**Musicman RD-50 112 mod**

DRAWN J. McCarty 9-3-80	MUSIC MAN INC. ANAHEIM, CA.
CHECKED T. Walker 9-10	SCHEMATIC DIAGRAM - RD-50 AMPLIFIER
DESIGNED T. WALKER	
APPROVED T. Walker	SCALE
APPROVED WJW	DWG. NO. 5004
	SHEET 1 OF 1

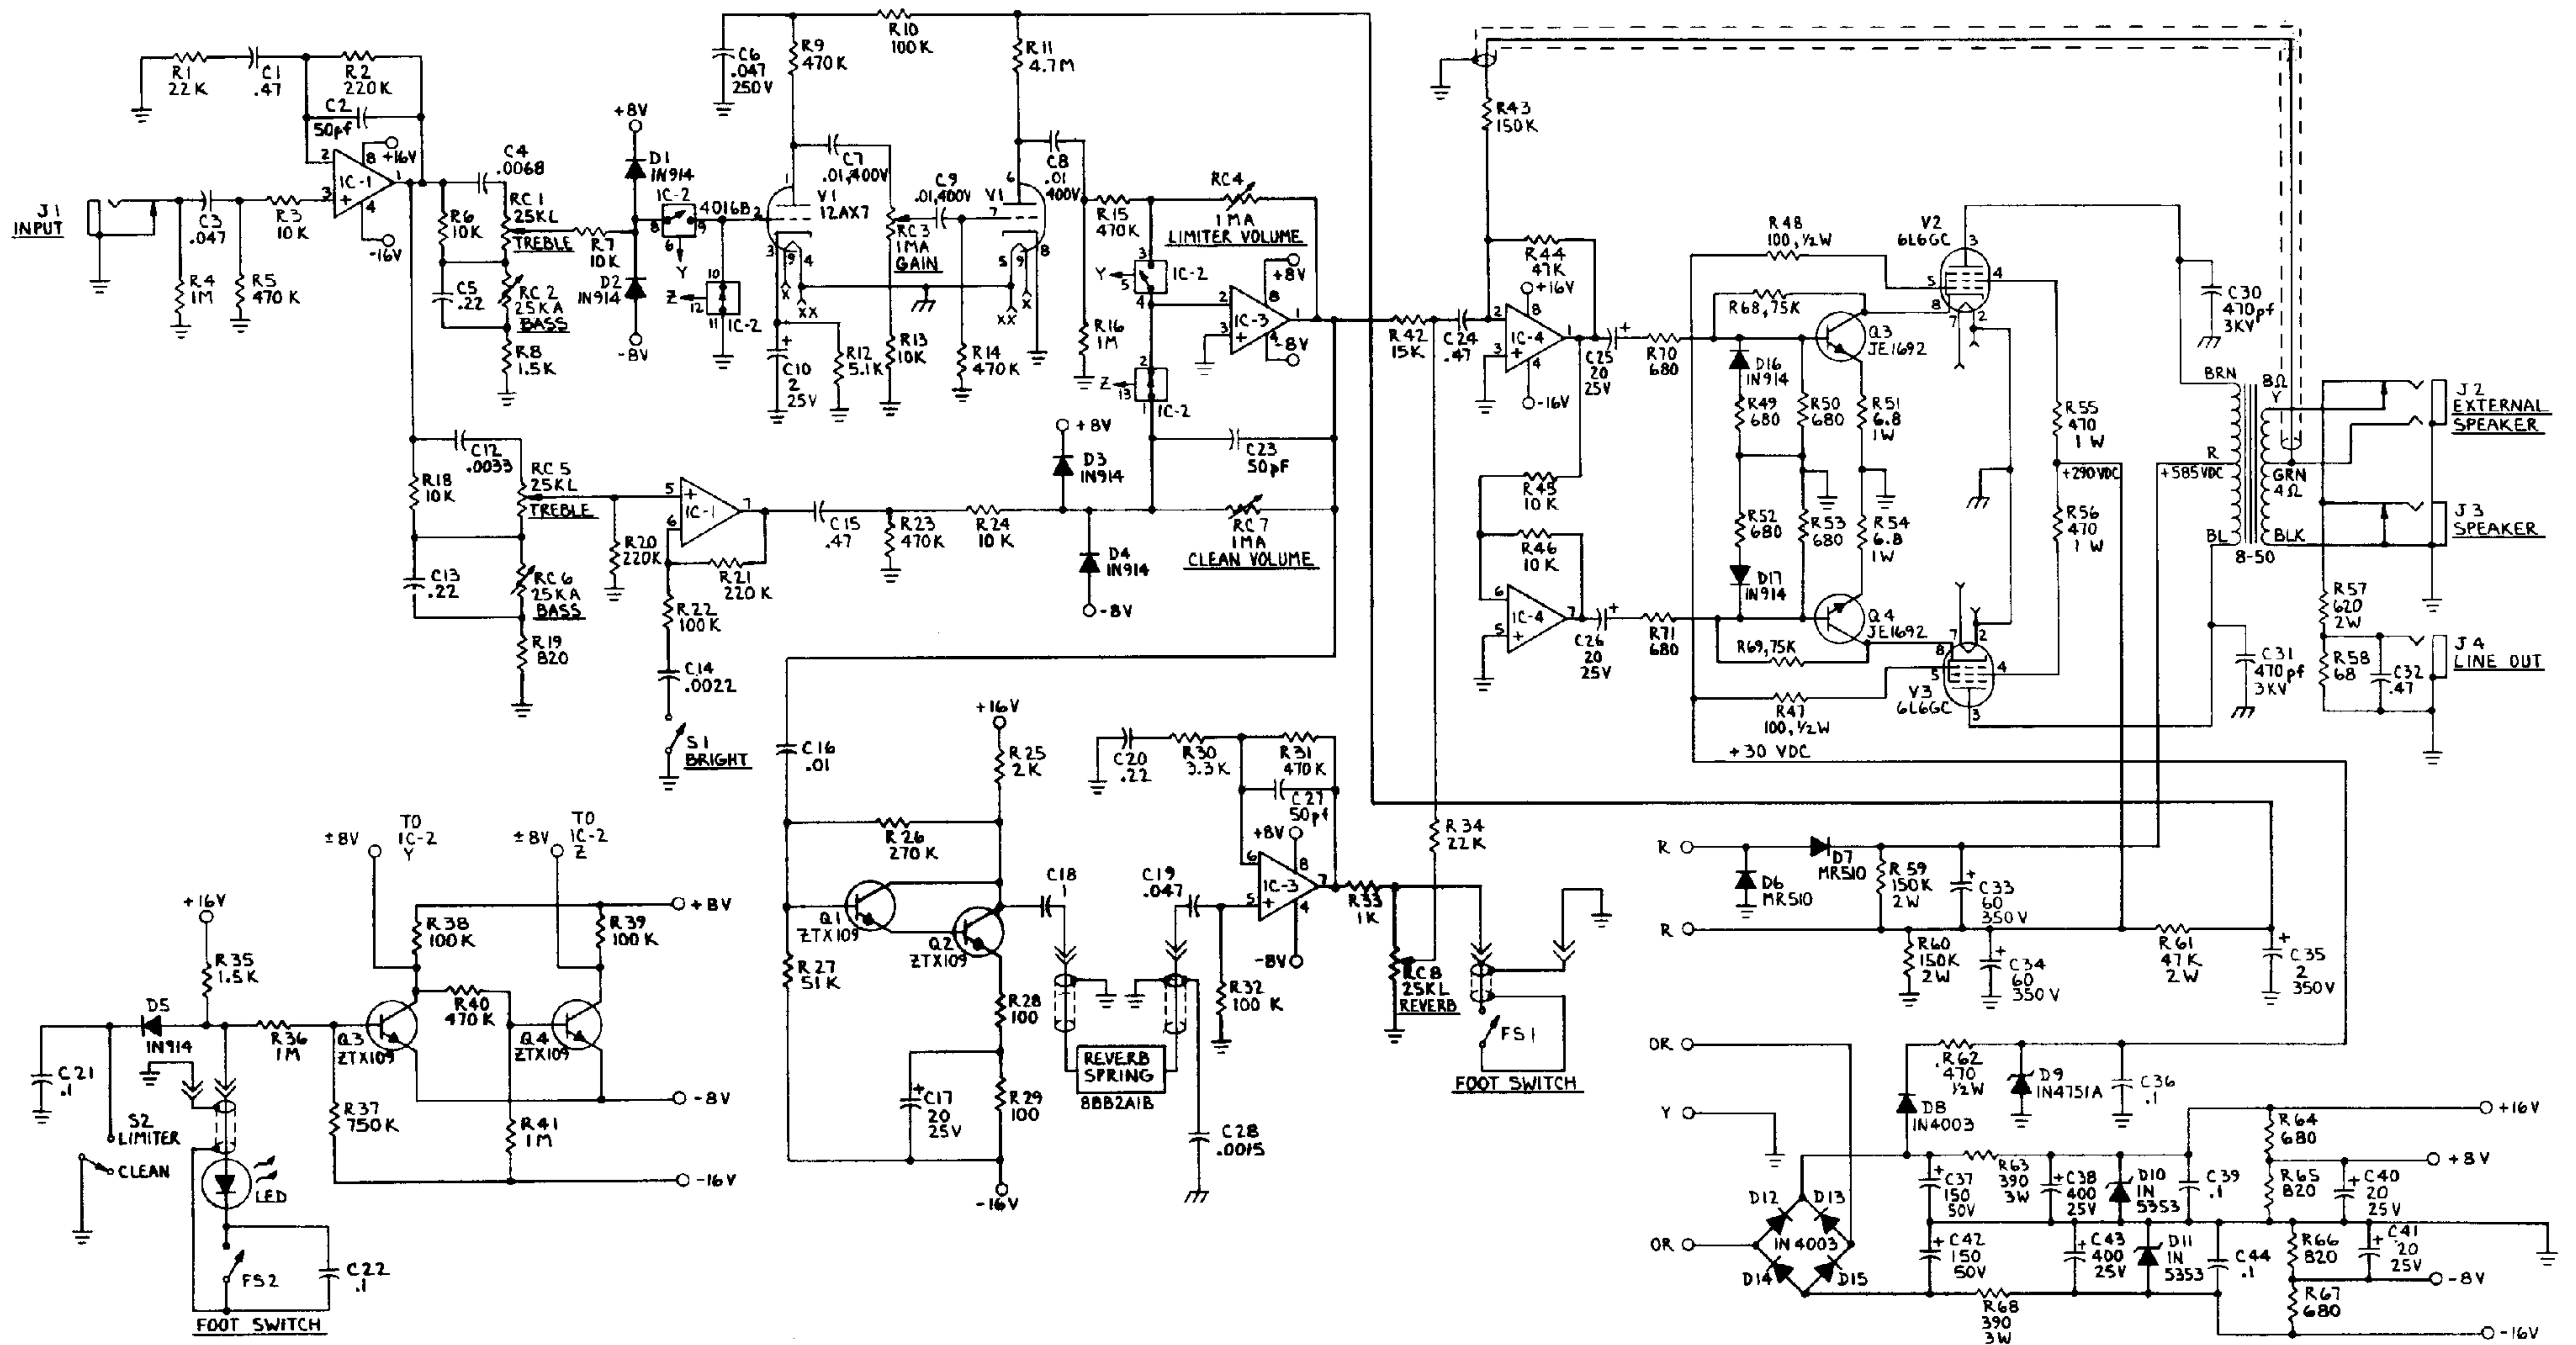
All,  
I'd like to share some of the mods I did to smooth the harsh top end of the Limiter channel typical for Musicman amps. In general, changed the V1a and b stages per the \*umble OD stages.  
In Particular:  
1. disconnected the cathode grounds and ground leads from C10,R12 at V1-8.  
2. Added a 5uf and a 1.8k at V1-8 and connected the grounds to the C10,R12,ground node.  
3. replaced plate resistors R9 (470k) with a 180k, and R11 (4.7M) with a 150k.  
4. replaced R10 with a wire jumper.  
5. removed grin wire at V1-7 and added a 150k series grid resistor.

Initially also added a 470pF across the Clean Vol pot, and a 1000pF across the Limiter Vol Pot to smmoth the harshness at all vol levels in either Clean or Limiter mode.  
The amp is much more useable and it definitely earned it's keep at last weekends gig. BobW
